DOCUMENT 00 90 00
ADDENDUM

ADDENDUM: 2

PROJECT: WESTERN TECHNICAL COLLEGE
SPARTA PUBLIC SAFETY TRAINING SIM CITY
11177 COUNTY HWY 1
SPARTA, WISCONSIN 54656
PROJECT NO. 25039

FROM: HSR Associates, Inc
100 Milwaukee Street
La Crosse, WI 54603
(608) 784-1830

1 1-OVERALL PLAN

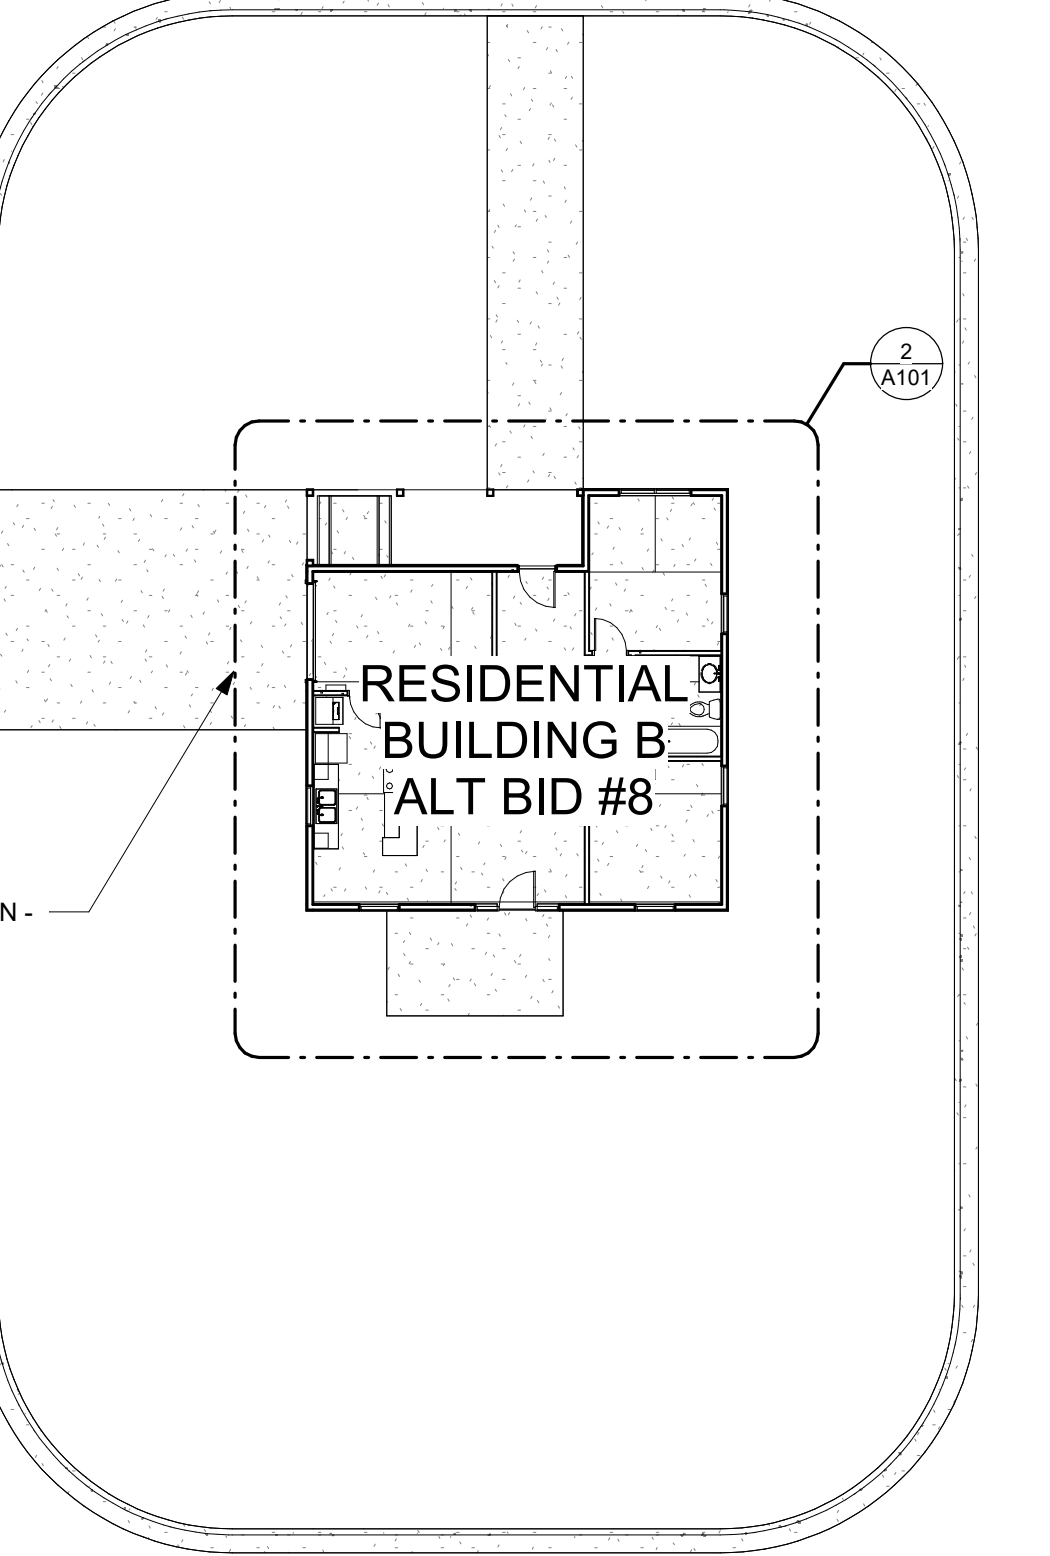
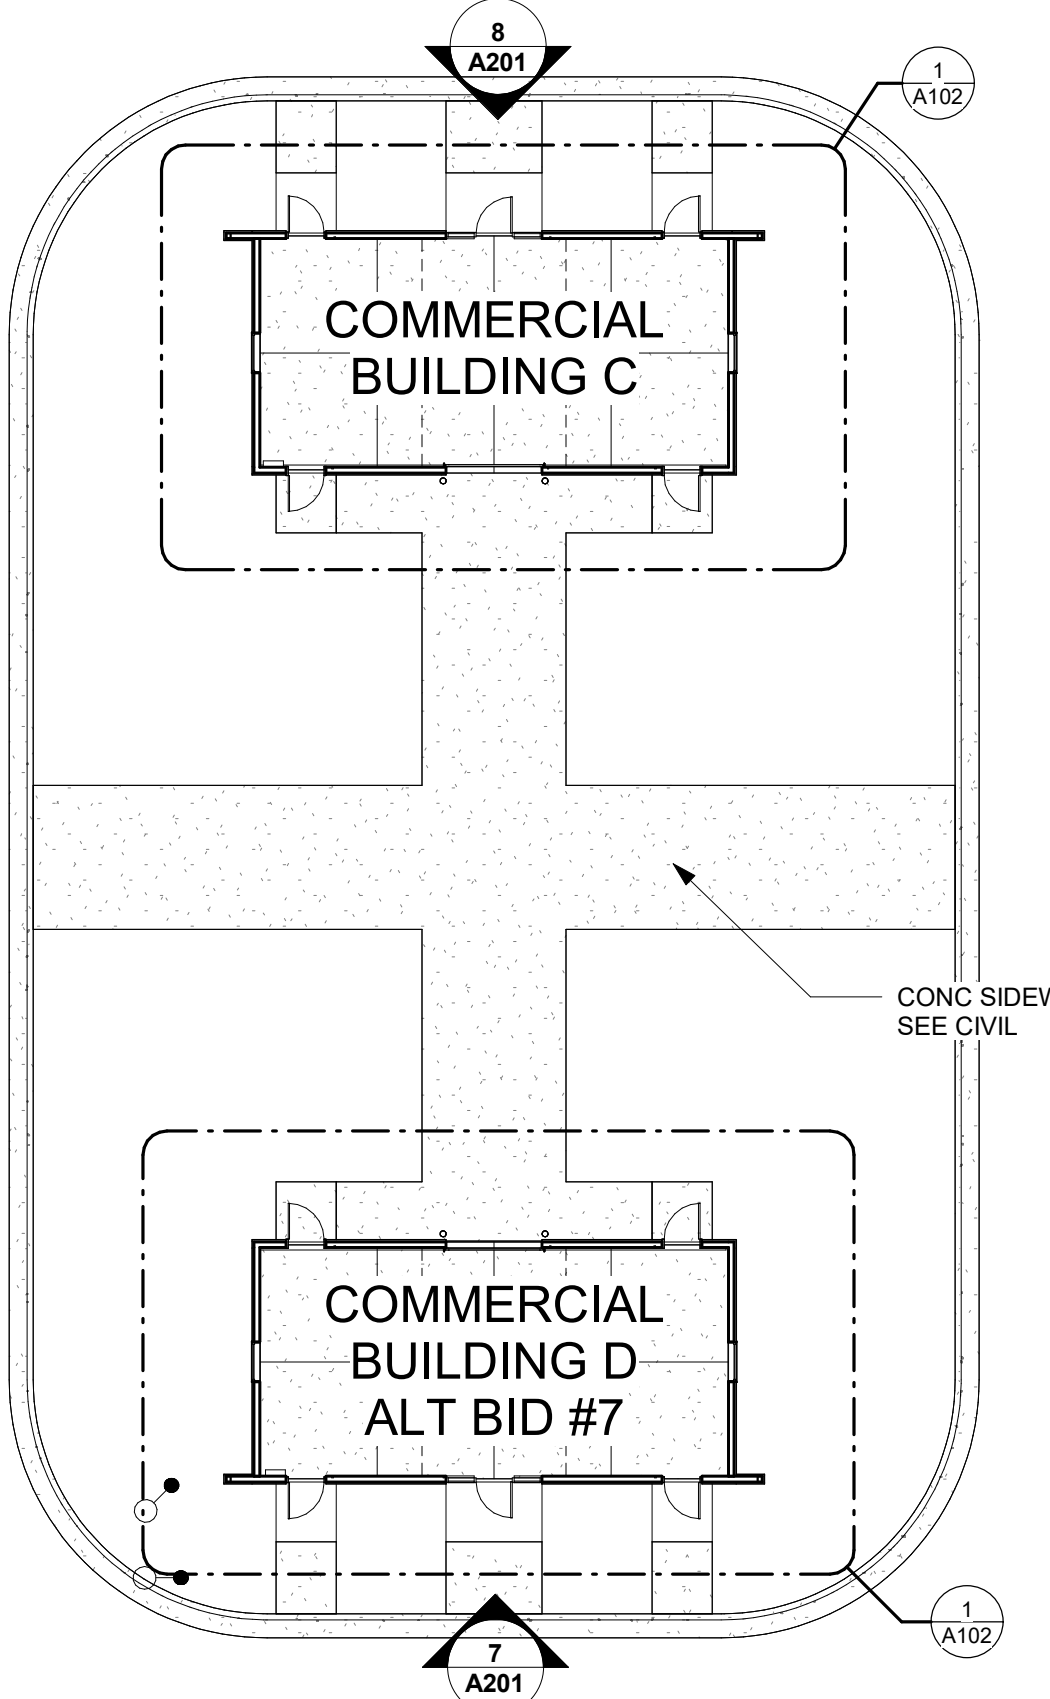
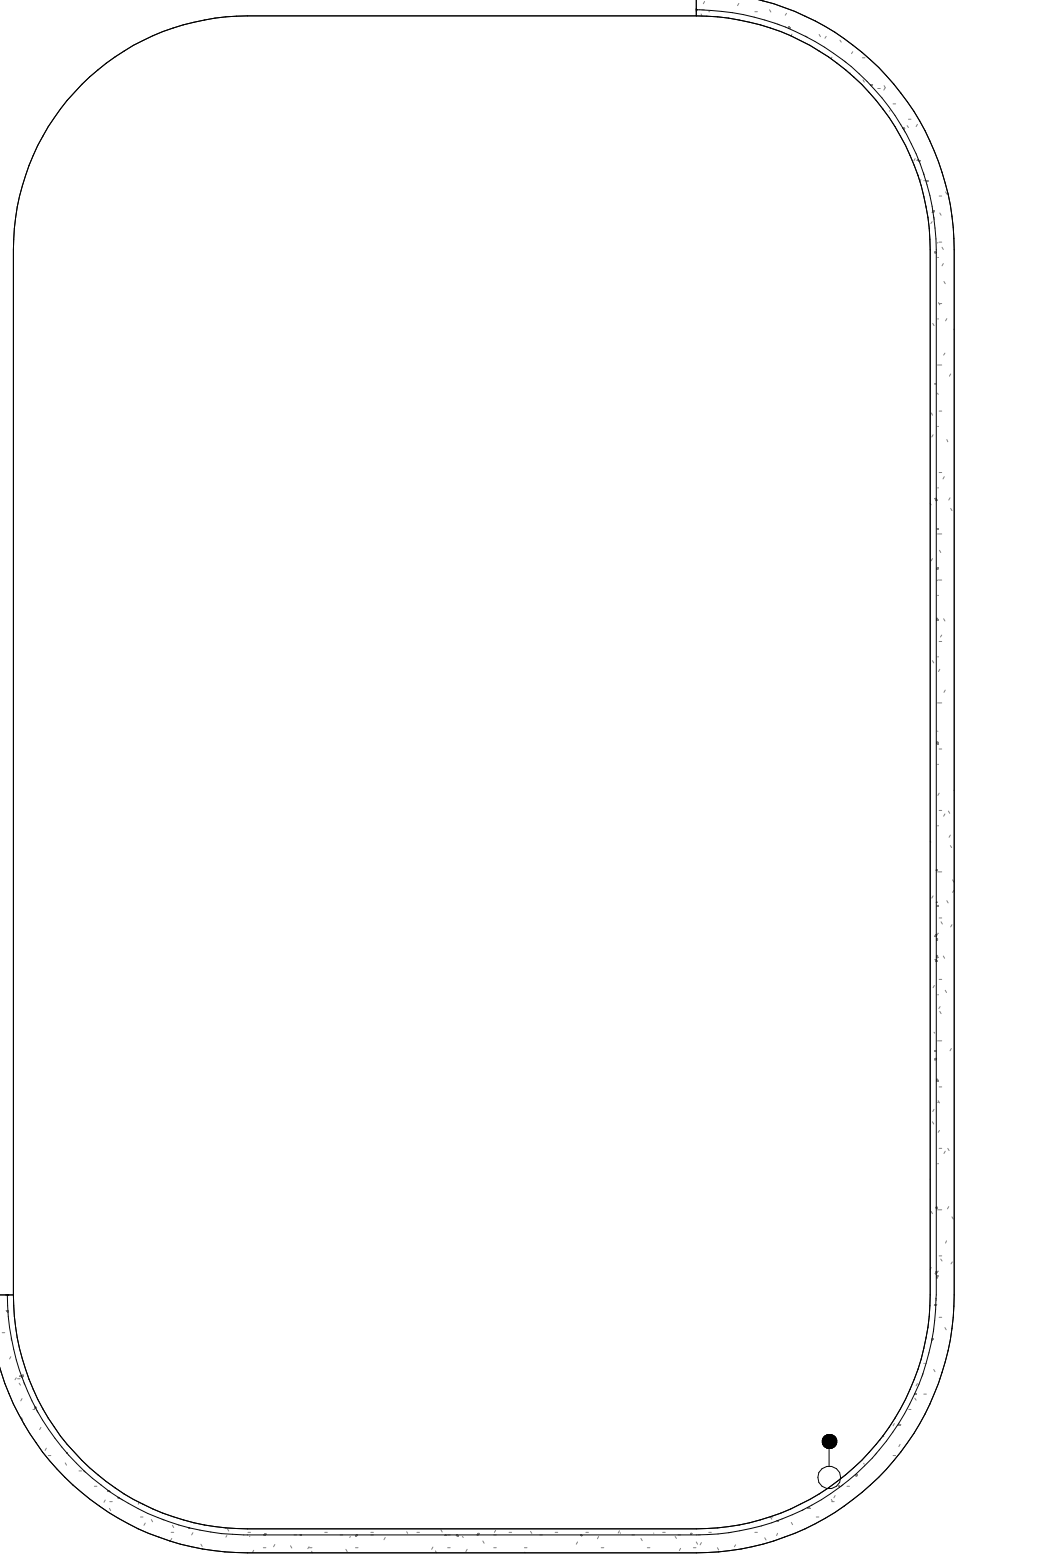
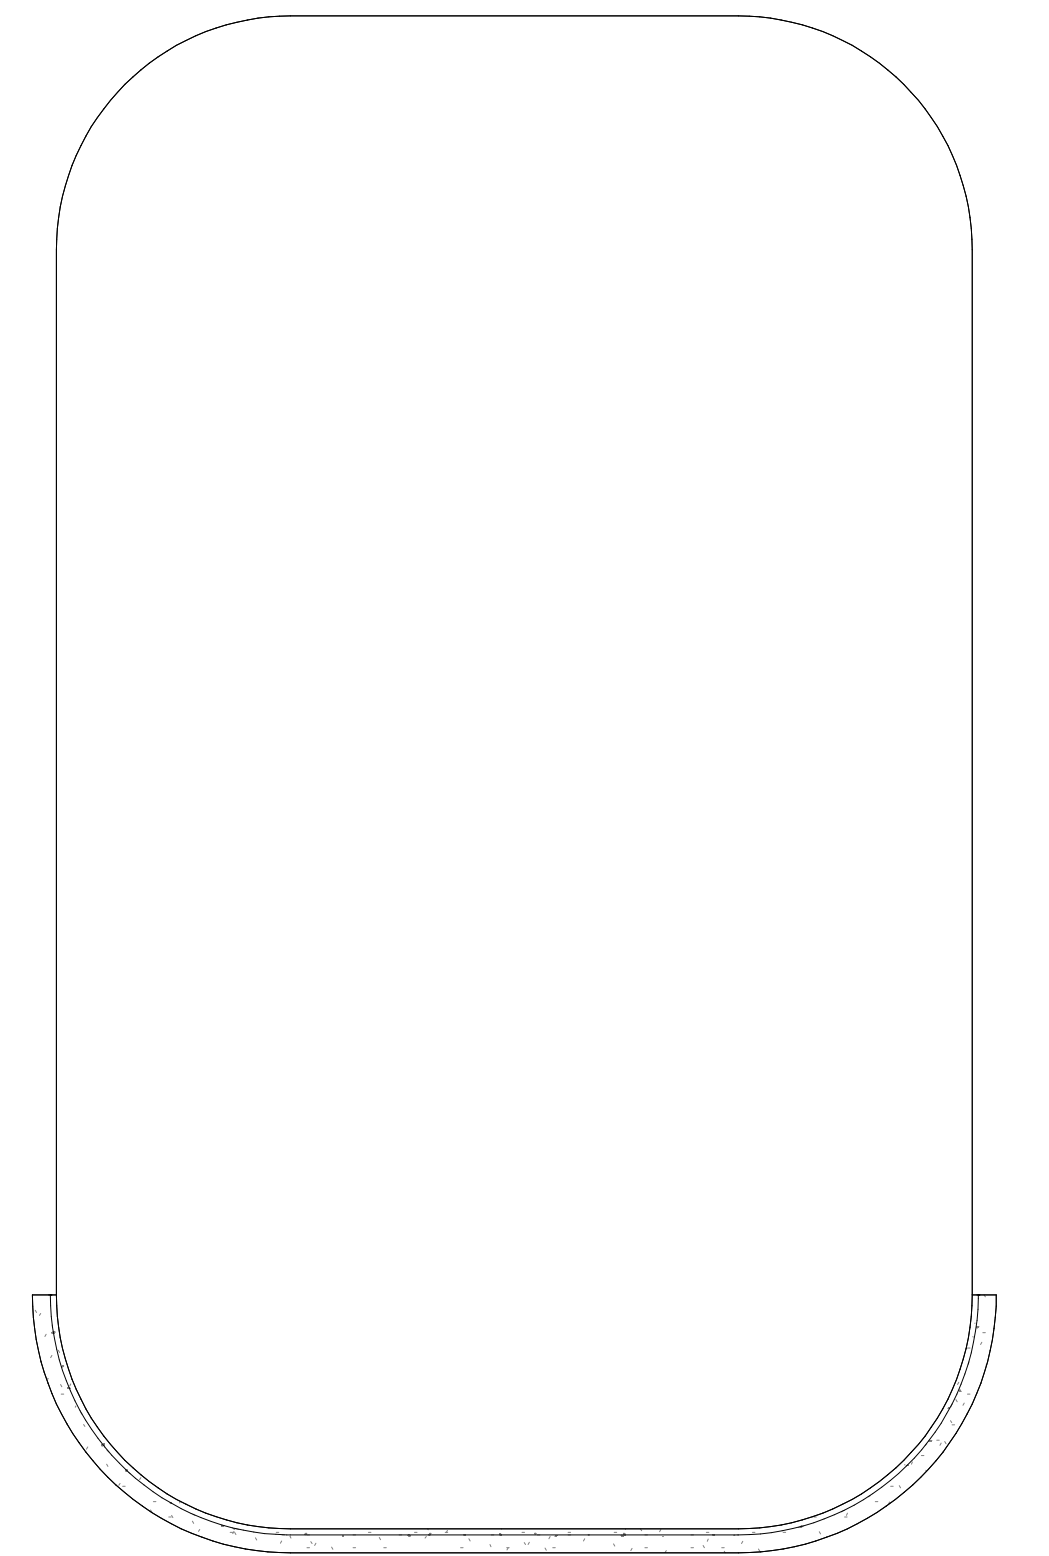
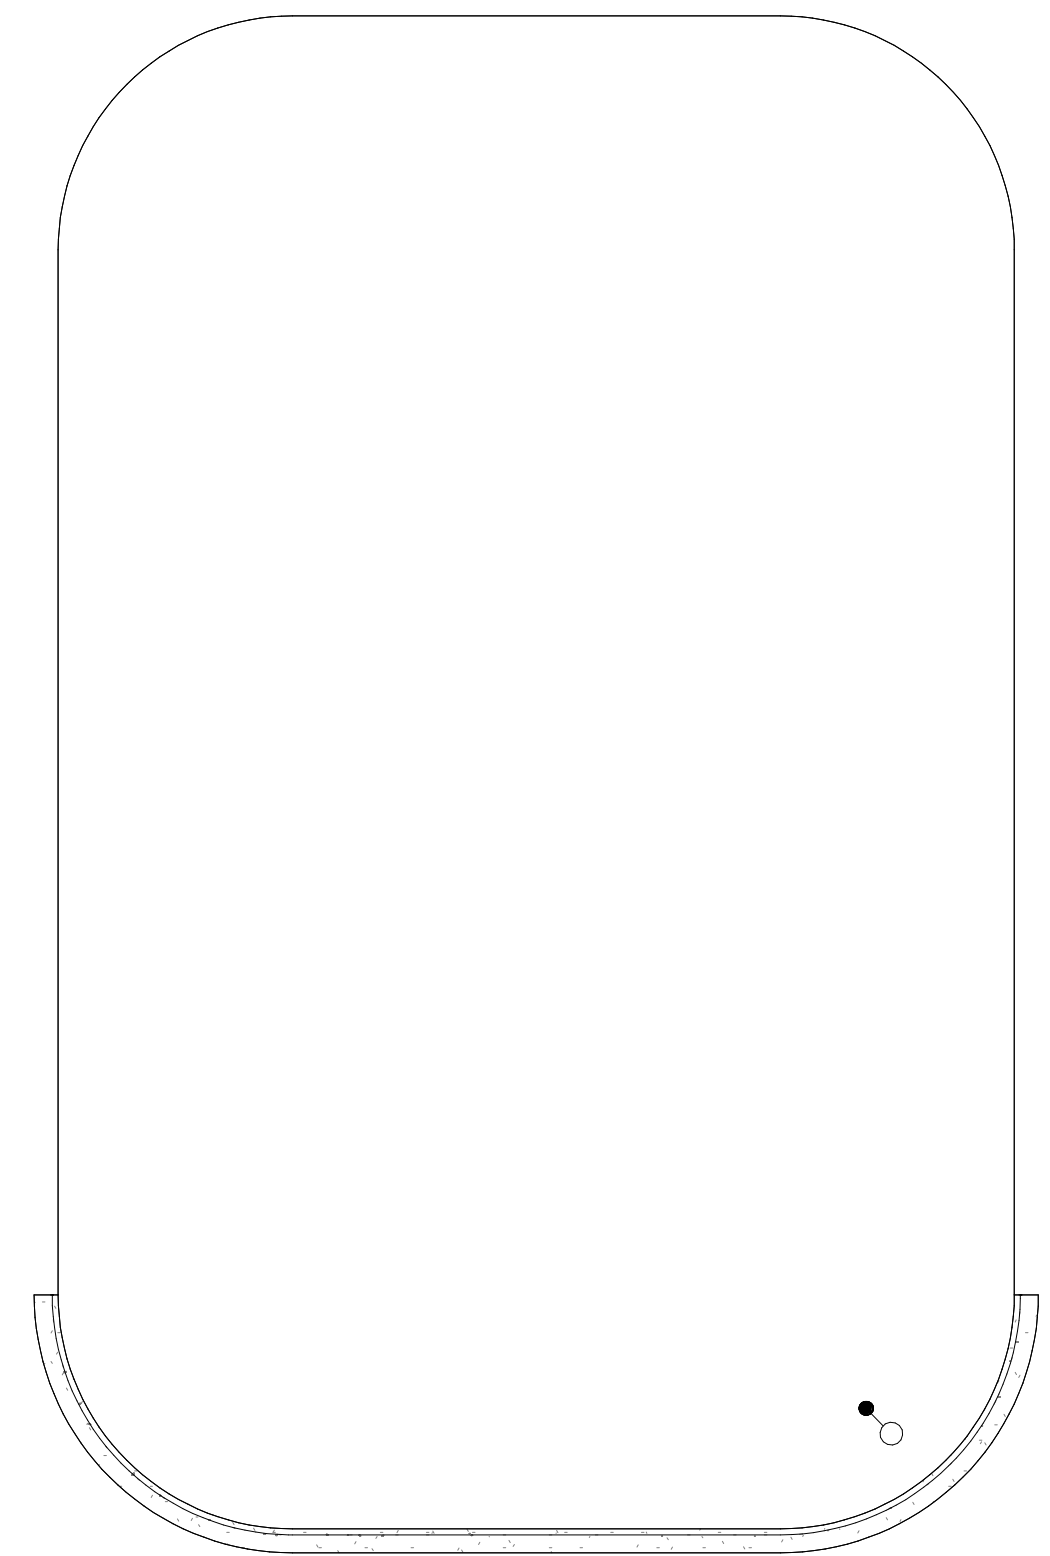
- a. See the revised sheet included in this addendum. Disregard the previous version.
 - b. Revised the location of the sectional door on commercial building B.

- c. Relocate associated items such as exterior lighting and bollards.
21. Sheet A101 FLOOR PLANS – RESIDENTIAL BUILDINGS 30"x42"
 - a. See the revised sheet included in this addendum. Disregard the previous version.
